SITE LOCATION: 528 Highland Street**AGENDA ITEM: II.w****HISTORIC DISTRICT:** Woodland Heights**HPO File No. 140224****Owner:** Michael and Laura Czapski**Applicant:** same**Date Application Accepted:** 1/21/2014**90-day Waiver:** N/A**SITE INFORMATION:**

TYPE OF APPROVAL REQUESTED: Alteration – Construction of a 2-story 2,078 square foot addition and attached garage to a 1634 square foot 1-story contributing house.

CERTIFICATE OF APPROPRIATENESS

Site Plan

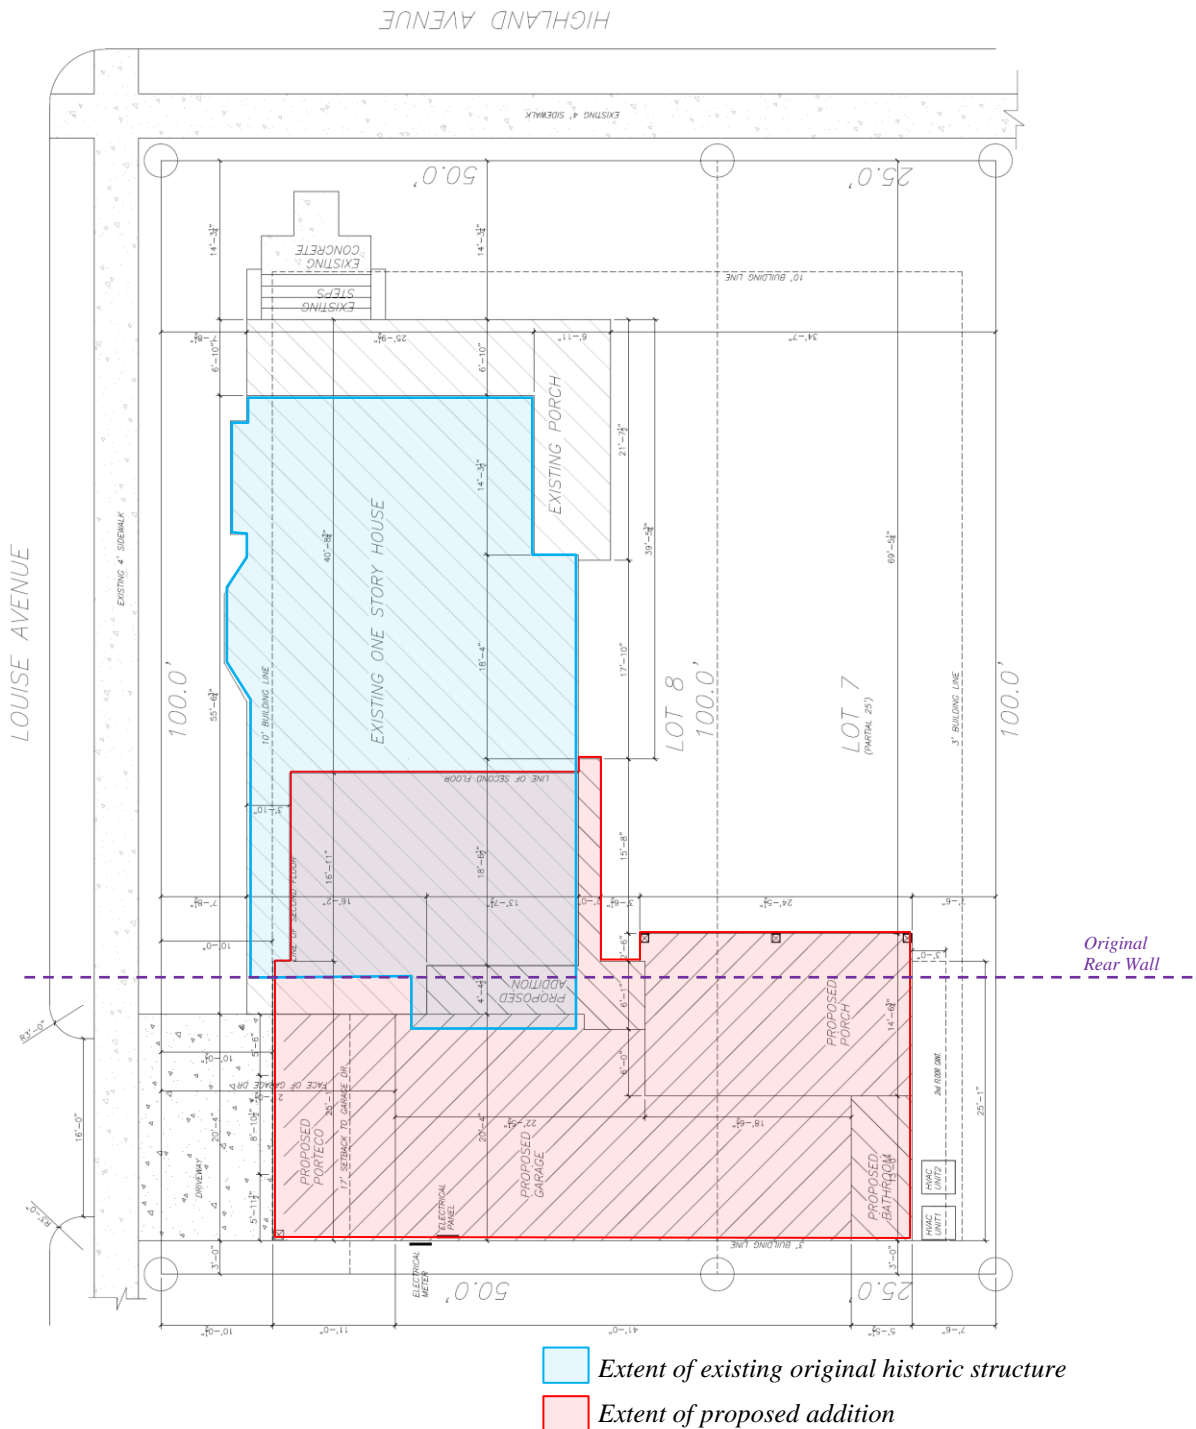
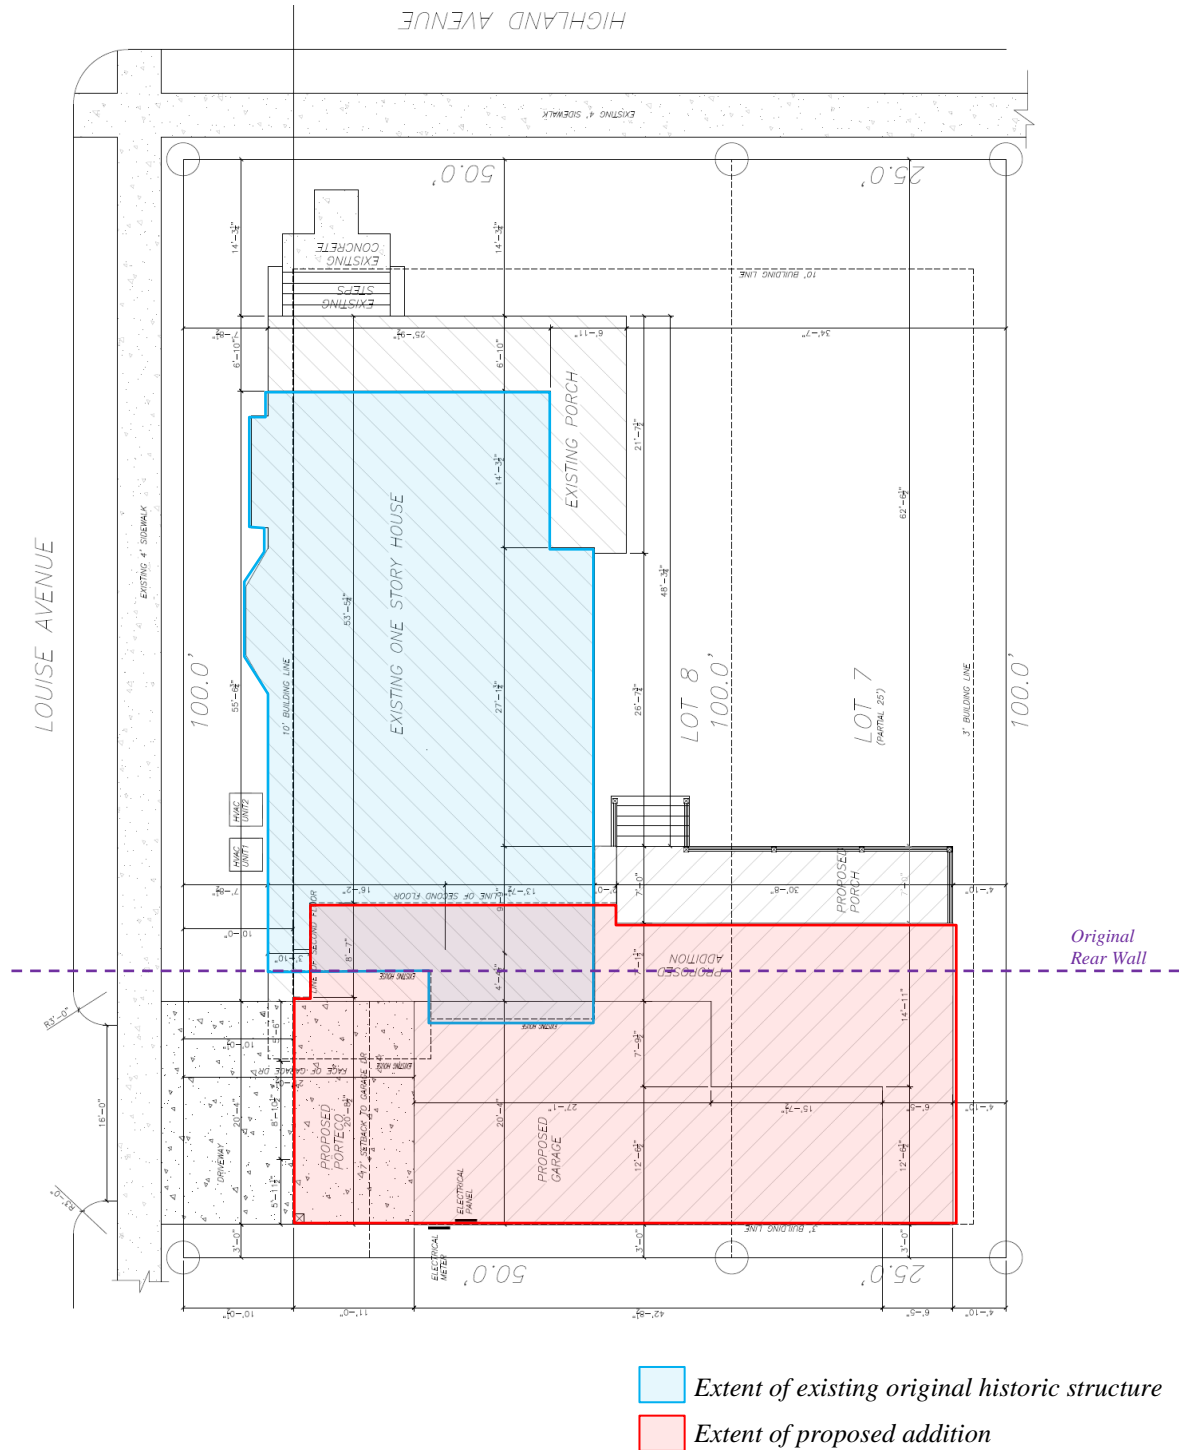
The applicant was denied a COA for a two-story addition at the November 2013 and January 2014 meetings. The applicant has since revised the proposed addition and submitted a new application. The plan is to construct a two-story 2,078 square foot addition and attached garage to the rear and to the side of an existing one-story 1,616 square foot contributing residence. The existing garage will be demolished.

The initial proposal had a total width of 65'-4" and a total depth of 42'. The ridge height of the initial proposal was 31'-8". The addition of the initial proposal began approximately 32'-8" (62%) from the front wall (approximately 38% forward of the rear wall) and a portion of the addition was inset 3'-10" into the existing roof along the west side of the existing structure.

The proposed addition will retain the front (north) setback of 14'-3" and have an east side setback of 4'-10"; a west side setback addition of 10'-1"; and a rear (south) setback of 3'. See drawings for more detail.

STAFF RECOMMENDATION: Approval of the COA**CERTIFICATE OF APPROPRIATENESS**

East Elevation (facing side property line)

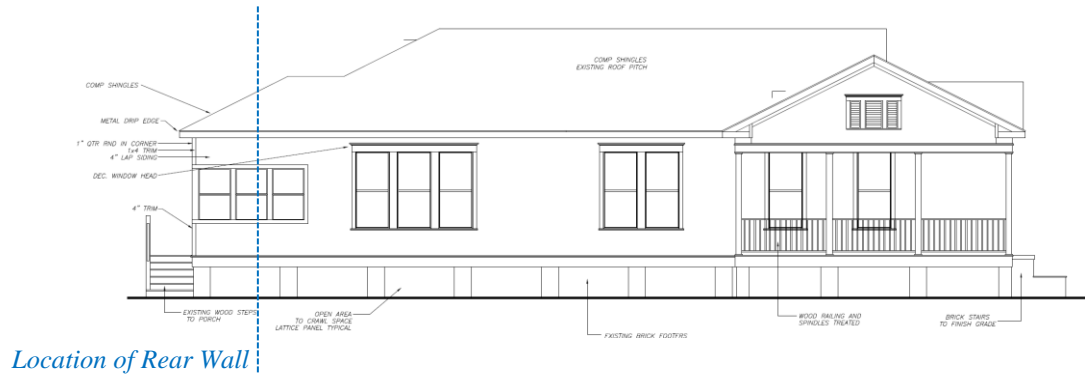
The proposed addition will begin approximately 6'-6" from the original rear wall of the house. The ribbon of three 1-over-1 windows and the southernmost window in the grouping of three 1-over-1 windows and the will be removed. In their place, a French door will be installed and the addition constructed. The remainder of the first-story will not contain any additional fenestration. The second-story will have two tall 1-over-1 wood windows. A front gable roof and hipped roof will top the addition. See drawings for more detail.

South Elevation (facing rear property line)

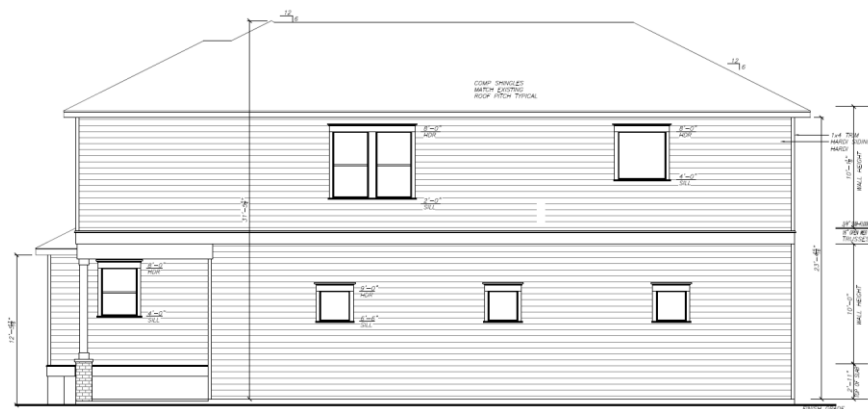
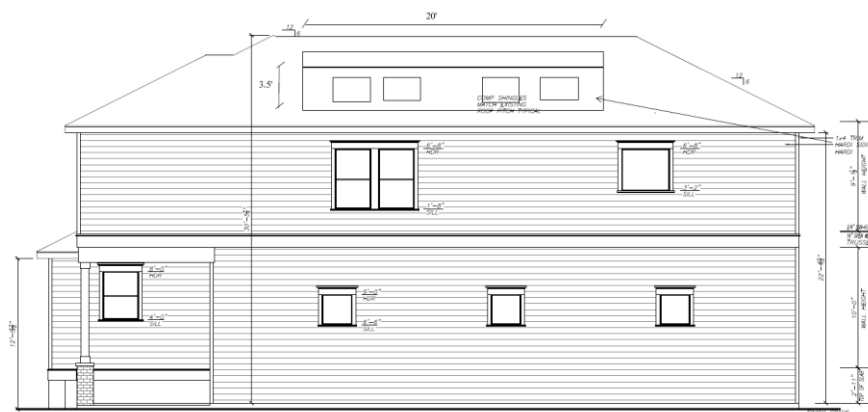
The proposed rear elevation will have the second-story overhanging the western portion overhanging the rear addition by 11', supported by a square column set atop a brick pier. The first-story will have one 1-over-1 window and three square fixed windows. The second-story will have pair of 1-over-1 windows and a single fixed window. The addition will be topped by a hipped roof. See drawings for more detail.

Proposed Floor Plans

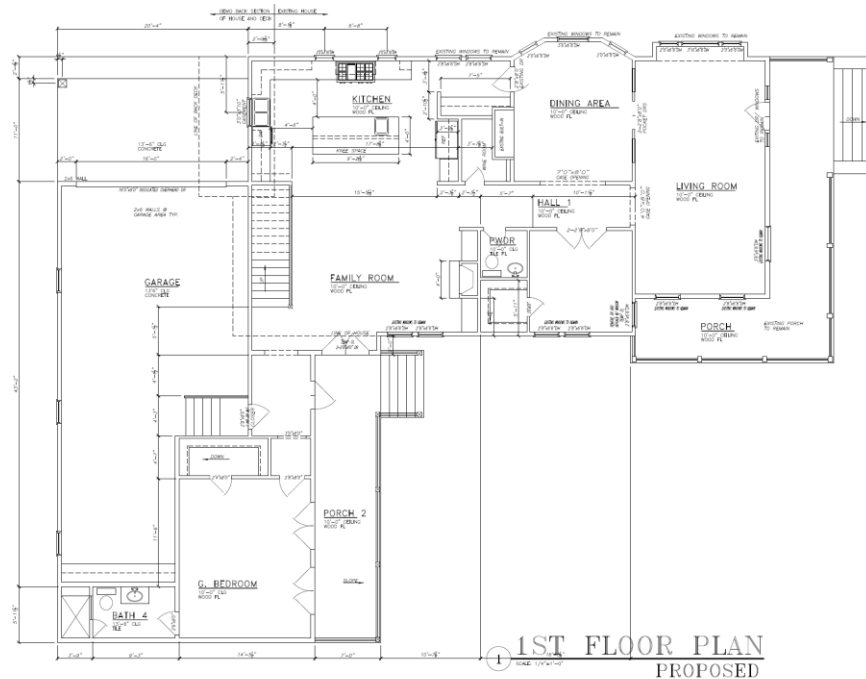
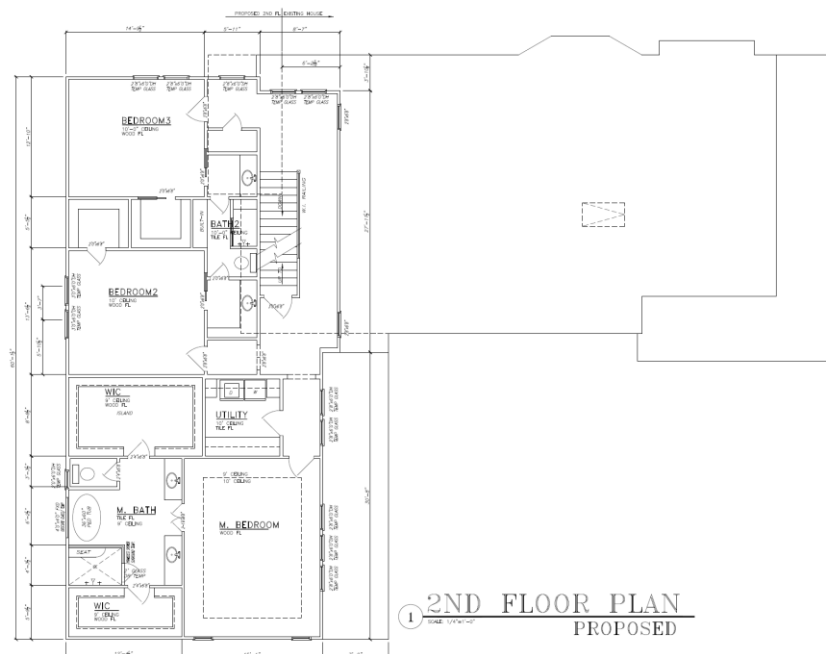
The majority of the proposed windows will be wood 1-over-1 sash windows, however, there will be several fixed wood windows. Several windows towards the rear will be removed or shifted. One of the removed windows will be replaced with doors. The rear dormer will feature four 2'x2' wood fixed windows. See drawings and floor plans for window/door location, design, and dimensions.

The proposed addition will not alter the current foundation. The proposed garage and rear portion of the addition will have a concrete slab foundation. See drawings for more detail.

Roof Plan

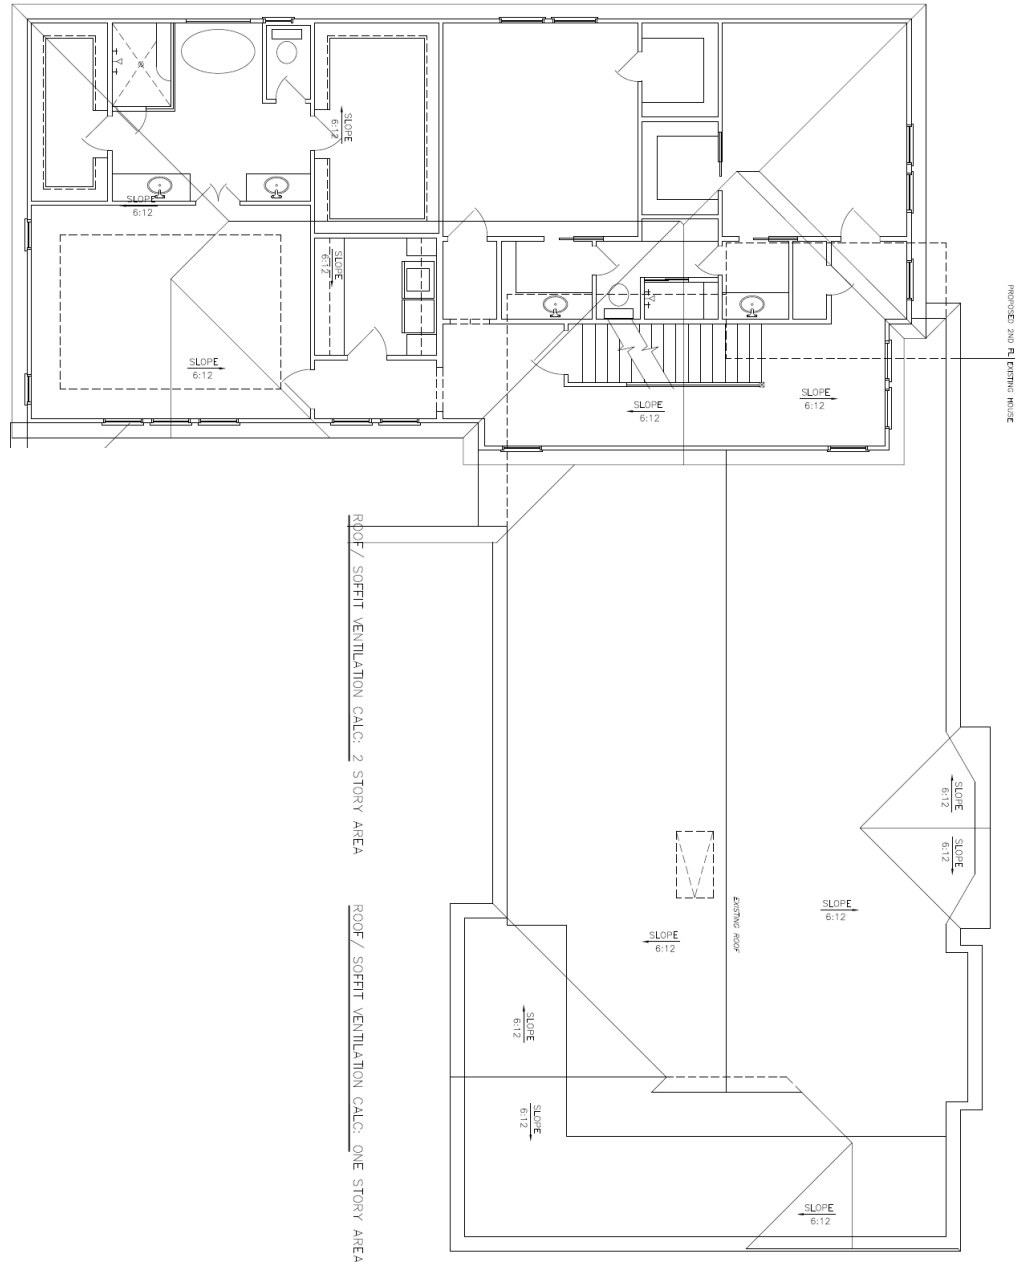
The proposed roof of the second-story addition will be hipped. The proposed roof will also be of a composition material and will have a pitch of 6:12. The proposed eave height will be 22'-5". A 20' long by 3'-6" tall dormer with a shed roof and four windows will span the rear portion of the roof. See drawings for more detail.
